UNITED STATES PATENT AND TRADEMARK OFFICE

09/761,375	01/16/2001	Terry N. Williams	11675.163.2	5328
------------	------------	-------------------	-------------	------

Office Action Summary

**FIG. 40**

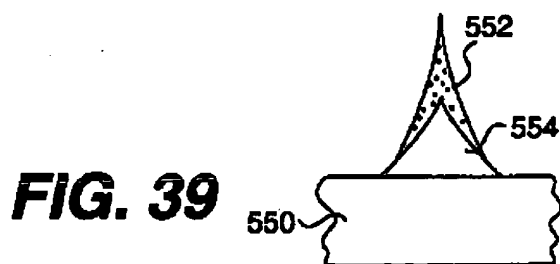
6. With respect to claims 9, 12, 15, and 20, Jones et al. disclose a field emission device comprising a substrate (Fig. 40, 642 & 644); a cathode conductive layer (646) disposed over the substrate; and an emitter tip (662) integral with an emitter layer (660) disposed over the cathode conductive layer and having a base adjacent to the emitter layer, an apex, and a continuously concave exterior surface extending from the base to the apex. Jones et al. also disclose: the exterior surface having a substantially

paraboloid vertical profile that extends from the base to the apex; and the exterior surface having an ovoid profile that extends from the base to the apex.

8. With respect to claims 10, 13, and 16, Jones et al. disclose a conductive gate structure (Fig. 40, 656 & 658) disposed over the cathode conductive layer (646); an aperture (664) through the conductive gate structure, the emitter tip (662) being

exposed within the aperture, and an anode panel (666) positioned over the conductive gate structure and the emitter tip.
